Jeans Manufacturing Co. Ltd (New location)

RISHIPARA, SHINGAIR ROAD, HEMAYETPUR, SAVAR, DHAKA
(23.792031, 90.259013)

20th March 2022

Exposed rebar of floors

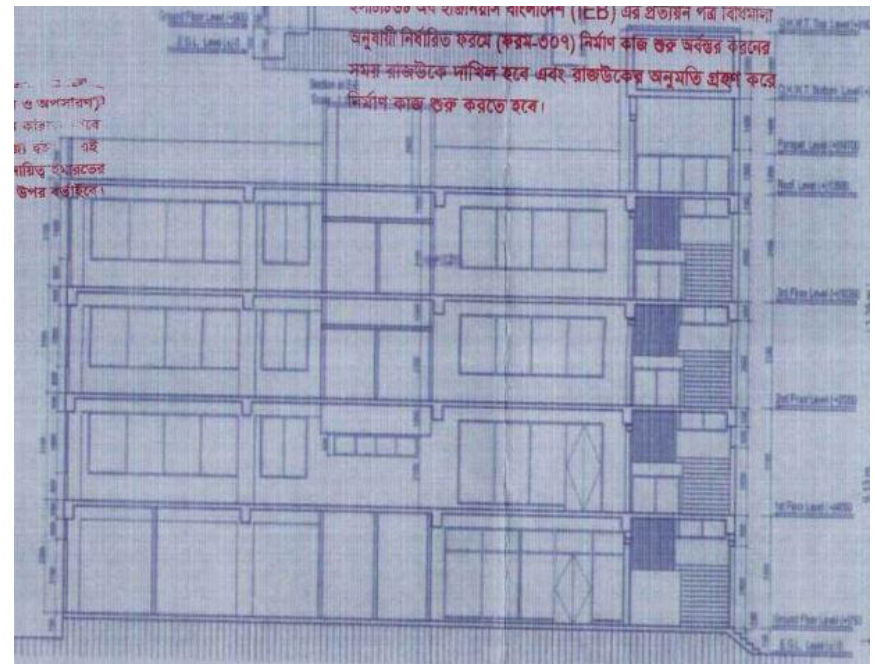
Exposed re-bar found

Exposed reinforcement was found extended from slab & beam. All exposed reinforcement is to be protected from corrosion which may cause degradation of the concrete. Factory engineer is required to take necessary measures to prevent the corrosion in exposed rebar.
